IN THE MATTER of applications for resource consent by the Central Plains Water Trust and a notice of requirement for the designation of land by Central Plains Water Limited associated with the construction and operation of the Central Plains Water Scheme

**STATEMENT OF EVIDENCE OF TIMOTHY REGINALD HOWARD DAVIES ON BEHALF
OF THE NORTH CANTERBURY FISH AND GAME COUNCIL AND
THE DIRECTOR GENERAL OF CONSERVATION**

Figure 1

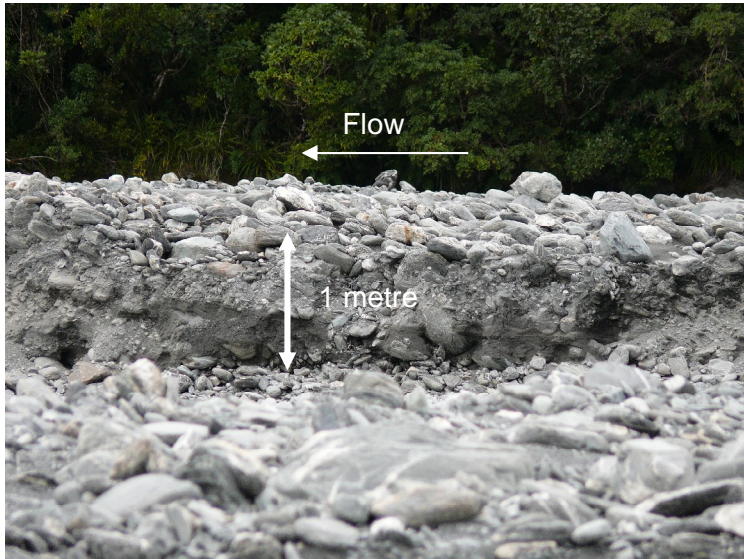
- 4.1 The evidence of Mr Mabin states that the presence on the bed of the Waimakariri River of a coarse armour layer is evidence that the river is under-supplied with bedload sediment. If this were true then all gravel-bed rivers would be undersupplied with bedload sediment, because they all display such an armour layer at low flow – including the Waiho River in Westland which has aggraded more than 10 metres in the last 50 years. It may be the case that the continued presence of an armour layer *during active bedload transport* indicates undersupply; but the beds of the

- 4.2 The armoured bed commonly seen in gravel-bed rivers is a result of the reduction in flow rate as a flood declines. The larger grains deposit on the bed and are unable to be moved by the reducing flow velocity, but smaller grains can still be carried away; since there is little sediment carried on the falling limb of a flood, these are not replaced and the result is a layer of larger grains. This has nothing to do with long-term undersupply of bed load – it is simply the result of conditions during reducing flow after the peak of a flood.

- 4.3 Figure. 1 (attached in the Appendix) illustrates a section through the bed of a gravel-bed river (Waiho River, Westland) which has undergone recent aggradation of some metres; the depth of sediment in the view is about one metre. This bed has an armour layer at its surface, caused by the process outlined in the preceding paragraph.

Figure 2

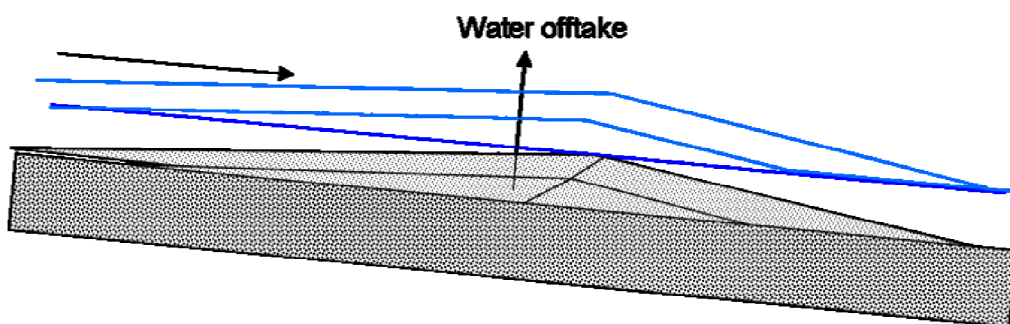
5.6 The AEE for the Waimakariri River Take near the Kowai River Confluence (URS, 2005) quotes values for the annual bedload transport rate of the Waimakariri of 233,000, 209,000 and 246,000 m^3 . Using 200,000 m^3 as a conservative figure, a 10 – 20% reduction means 20,000 – 40,000 m^3 per year of bedload sediment would not be able to be transported past an offtake section. This sediment would accumulate at the offtake, raising the bed level. The effect of the bed level rise is to increase the river's slope downstream of the offtake, so that the reduced flow rate of water available can transport the full sediment load in the steeper reach (Figure 2 in the Appendix). As bed level rises at the offtake the water surface slope upstream decreases, forming a backwater curve; the consequently reduced sediment transport rate here causes sediment to accumulate, the accumulation extending upstream with time.

5.7 The rate of bed level rise depends on the length of river over which the deposition is distributed; this will clearly increase as the bed level at the offtake rises. To increase the sediment transport capacity by, say, 15% to restore it to its original value, Eq. 1 shows that the slope S must increase by 10% downstream of the offtake, an increase of 0.0005 m per metre of river length (the river bed slope under normal conditions is 0.005). If we assume that sediment accumulation upstream of the offtake has a horizontal surface, then if 40,000 m^3 of sediment accumulate in one year this will build up to a maximum depth of 0.16 m at the offtake, with the tail of the deposit extending 200 m downstream. The upstream accumulation would extend 35 m from the offtake. After 10 years, under these assumptions, the increase in bed level would be 0.48 m, and after 100 years, 1.6 m, with the downstream effects at that time extending 2 km and the upstream effects 0.35 km.
